**CATAWBA COUNTY JUSTICE CENTER AND PUBLIC SAFETY CENTER EXPANSION
100-B SOUTHWEST BOULEVARD
NEWTON, NC 28558**

Little Project No. 111-6473-02

September 3, 2013

ADDENDUM NO. 1

A024

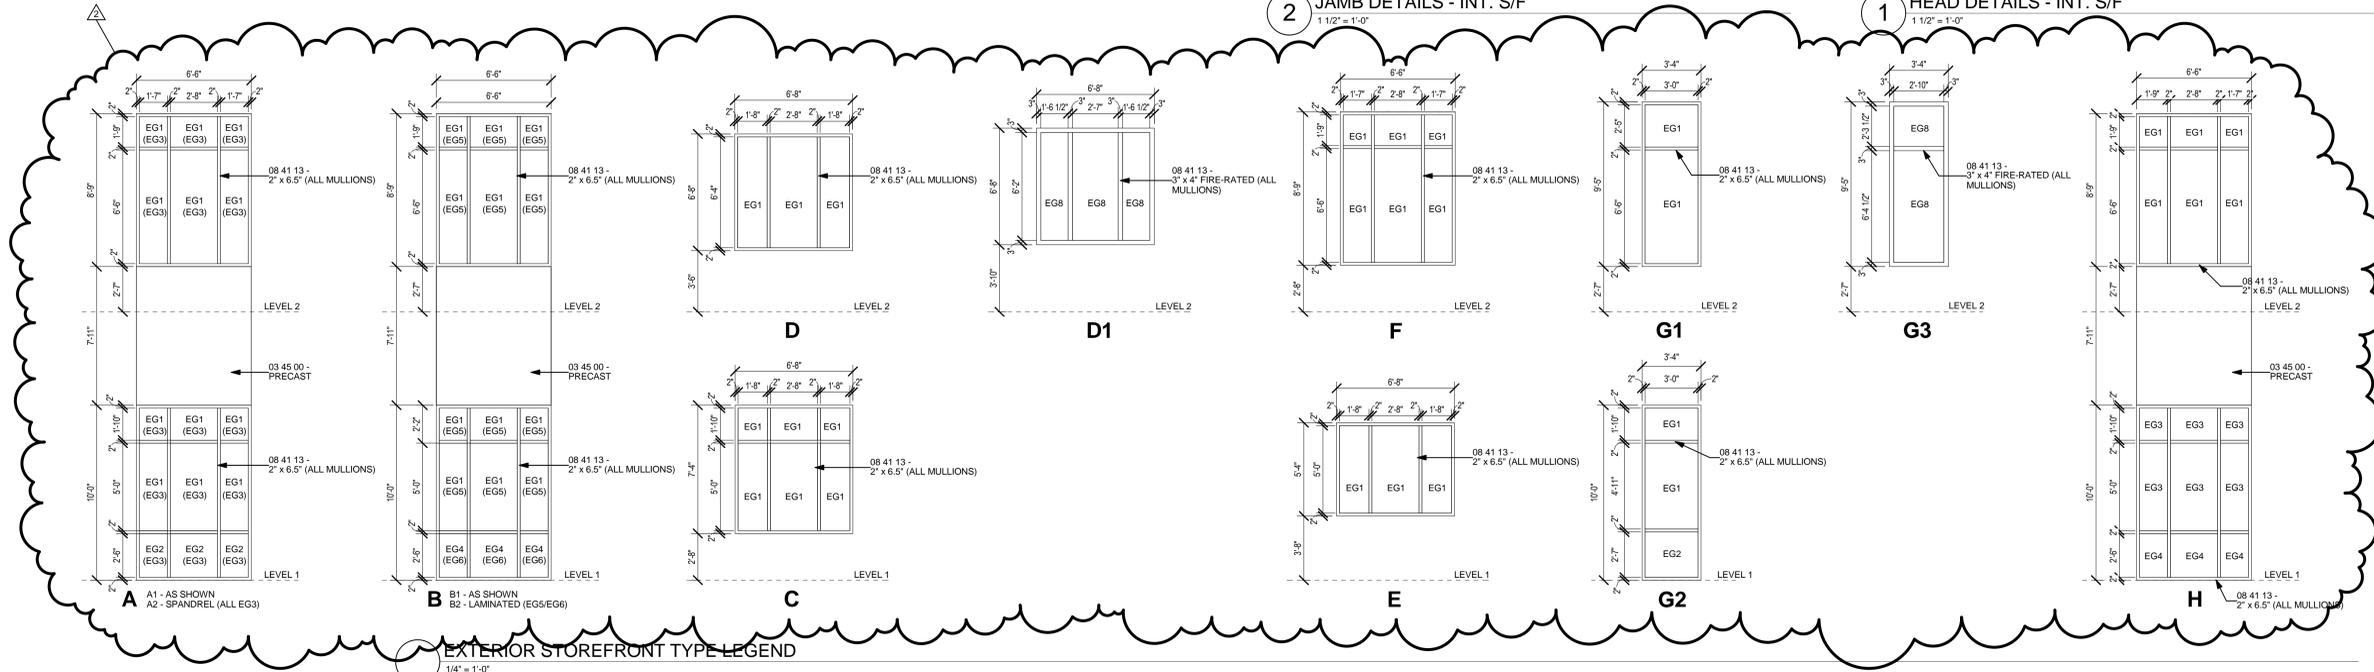
- 12. A024 calls for EG8 on all exterior windows. EG8 is fire rated glass. Please verify that all exterior glazing is to be fire rated. Also verify that all windows except D1 and G3 are to be un-rated frames. Those are the only two with notes regarding rating frames. Lastly, clarify what rating (minutes) each frame and/or glass type is to be.**

Response: Please see revised architectural sheet A024 for clarification on window glazing types. Typical exterior window glazing is EG1. Only window types D1 and G3 require fire rated glazing (EG8) and fire rated frames. Fire rating for rated windows is 60 minutes.

A711C

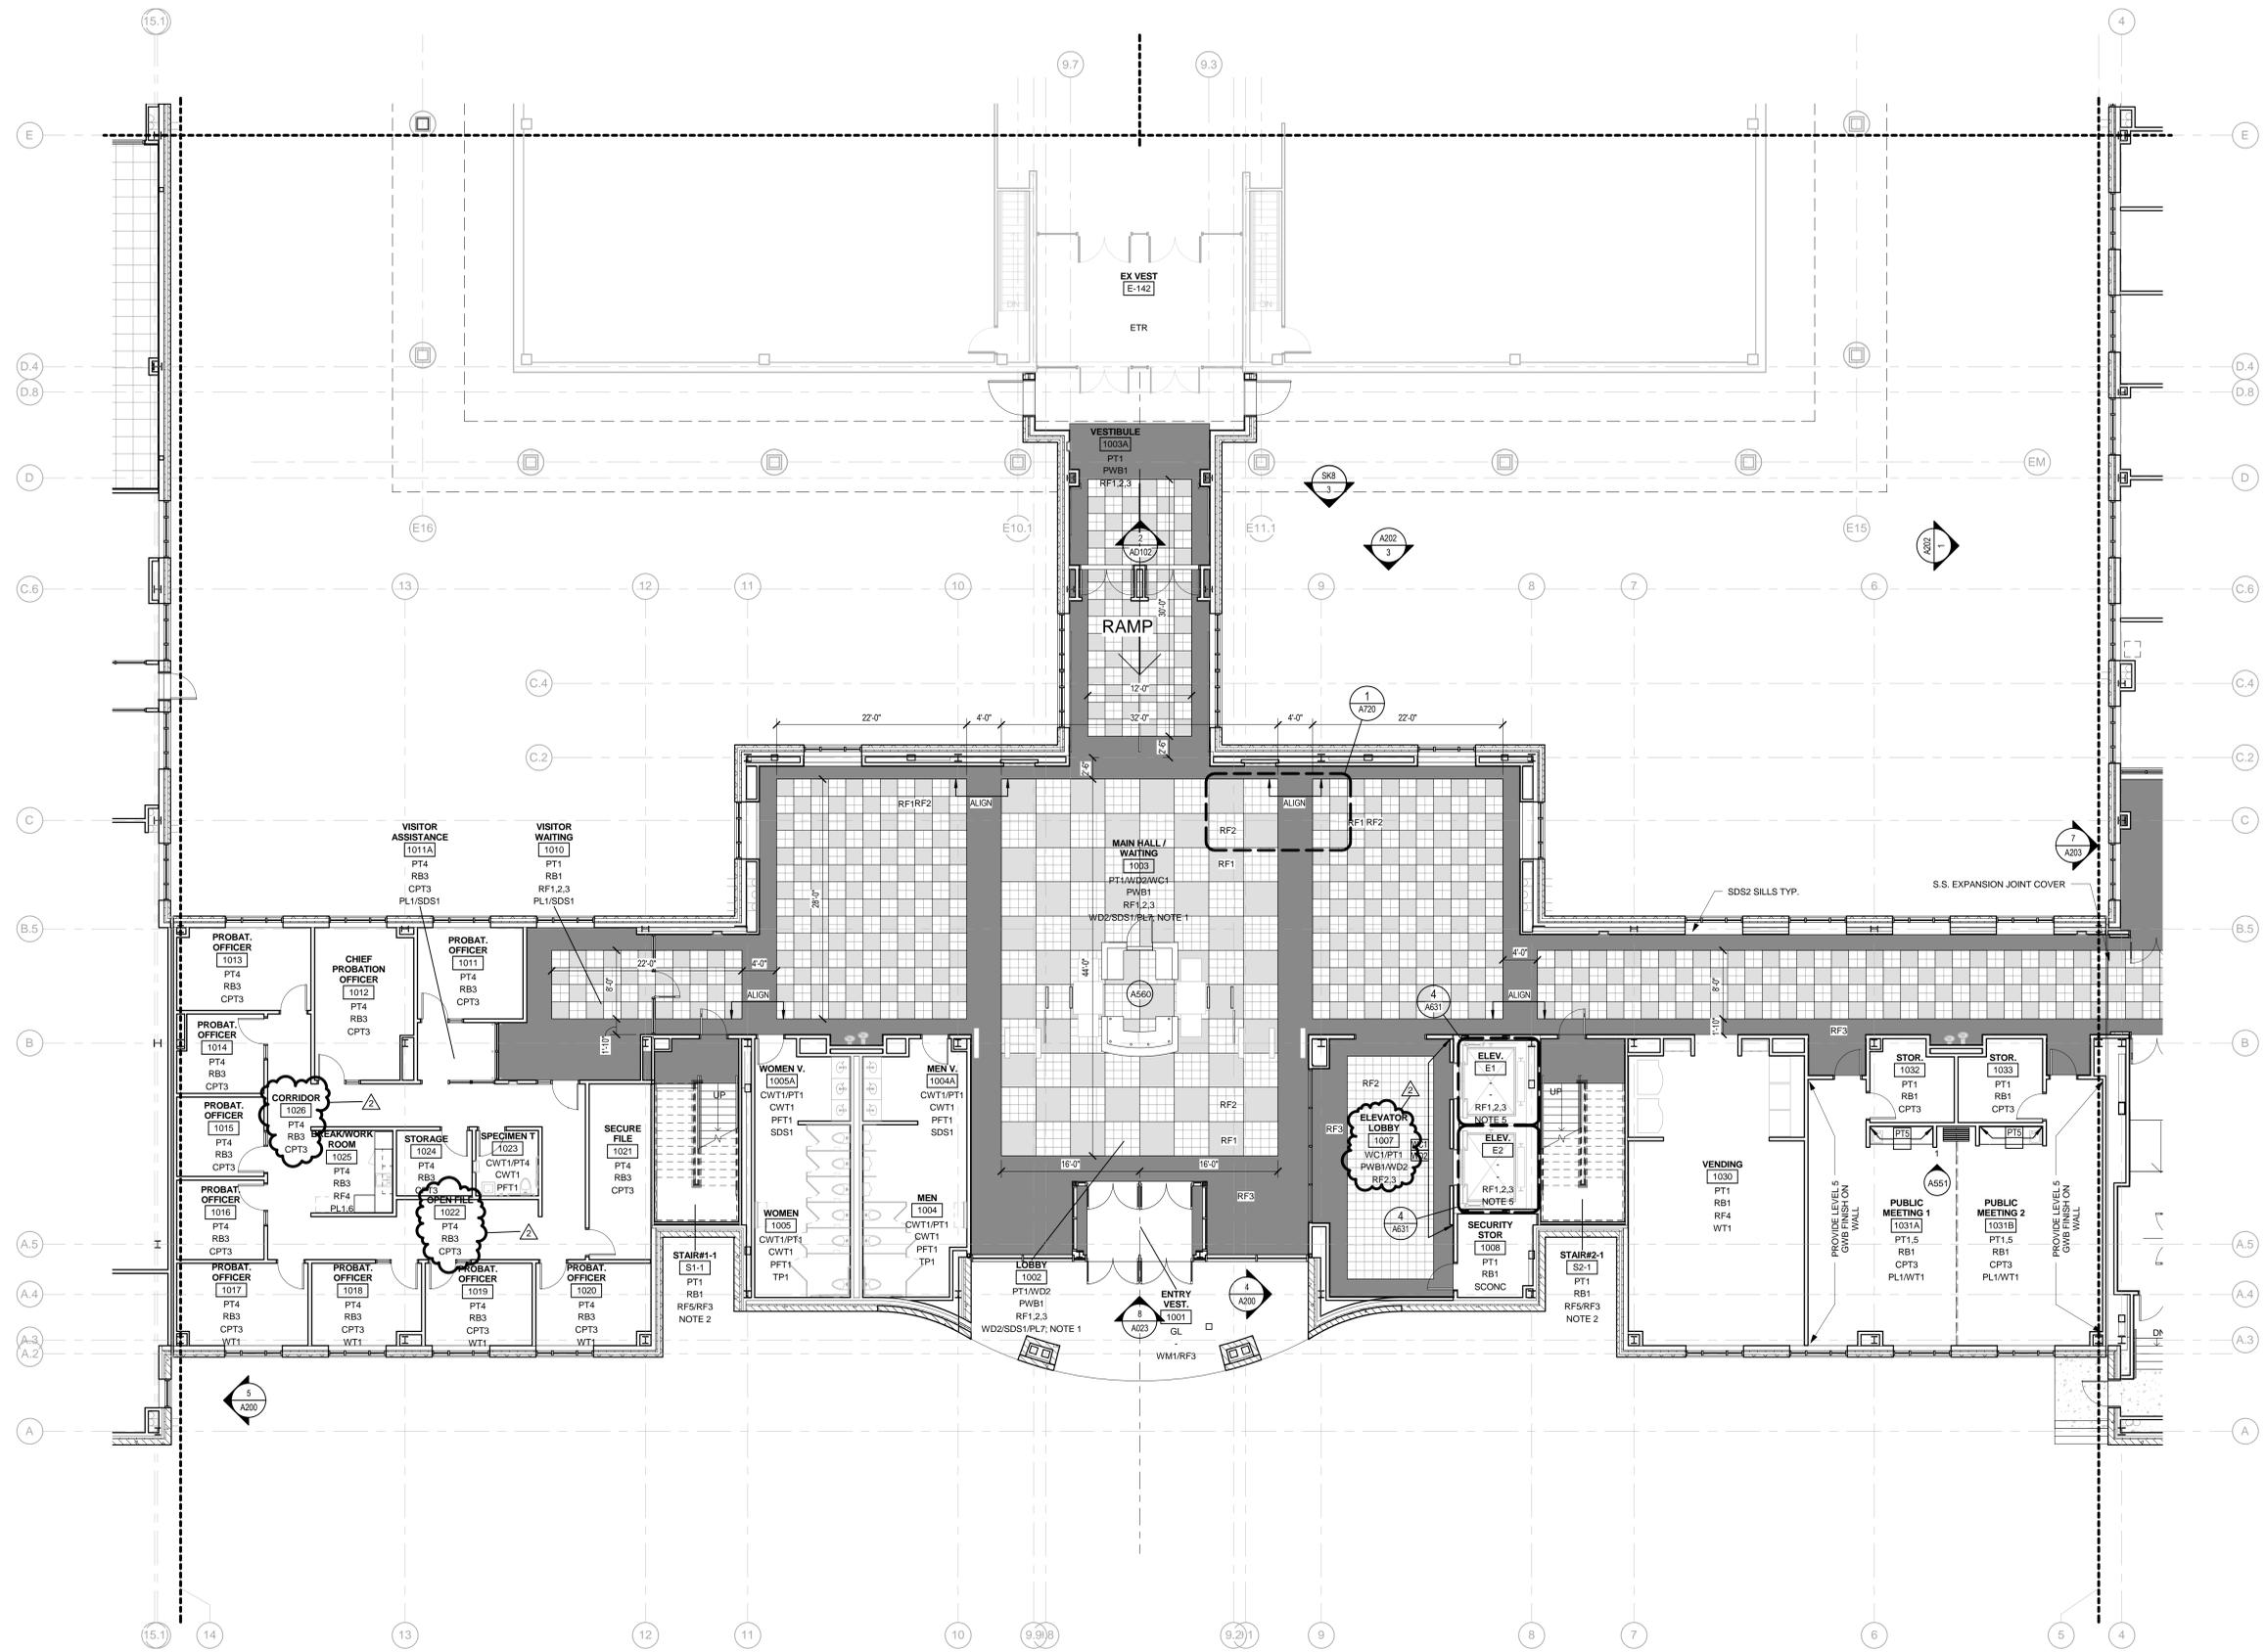
- 14. Sheet A711C: Please clarify reference to CWT1 at 1007 Elev. Lobby?**

- 16. What is the flooring finish for the Open File 1022 and Corridor 1026? It is not designated on the A711C plan sheet.**

Response: CWT1 has been changed to WC1.

Response: Both rooms are to receive PT4 on the walls, RB3 base, and CPT3 on the floor.
